ADDENDUM TO FRESHWATER ASSESSMENT REPORT FOR THE PROPOSED RELOCATION OF THE KOEBERG INSULATION POLLUTION TEST STATION AND CONSTRUCTION OF ASSOCIATED INFRASTRUCTURE

MAY 2017

Figure 1. Proposed layout for the new Koeberg Insulator Pollution Test Station

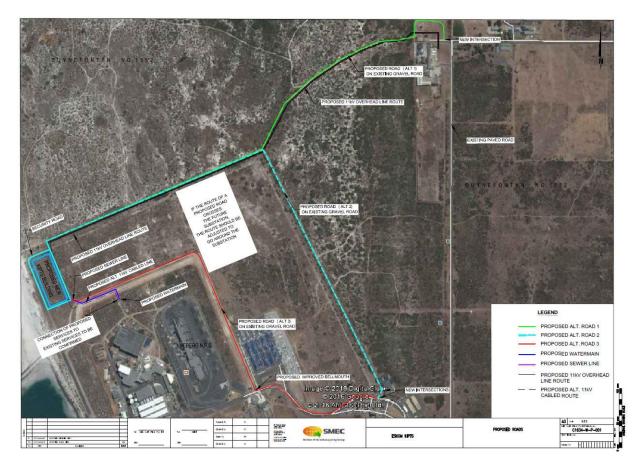
A freshwater assessment report has been compiled for the proposed KIPTS. The access road options assessed in the report are likely to change due to security issues with both of the preferred routes. The access road will however be constructed within the block between the red and blue routes (Alternatives 2 & 3), but the exact route will only be determined much later on once the security issues and the position of the future 400kV substation have been determined. This addendum report to the initial freshwater assessment report is specifically intended to address the altered road option.

Provided the wetland area indicated in the highlighted bullet above is avoided, no additional wetland areas were identified within the area indicated for the new access road alignment (Figure 2). *The proposed changes to the KIPTS and its associated infrastructure are thus not likely to result in an increased level or nature of impact, or result in a change to the significance of the impact assessed in the original freshwater impact assessment for the proposed project.* No additional mitigation measures to those recommended in the original specialist report are required.
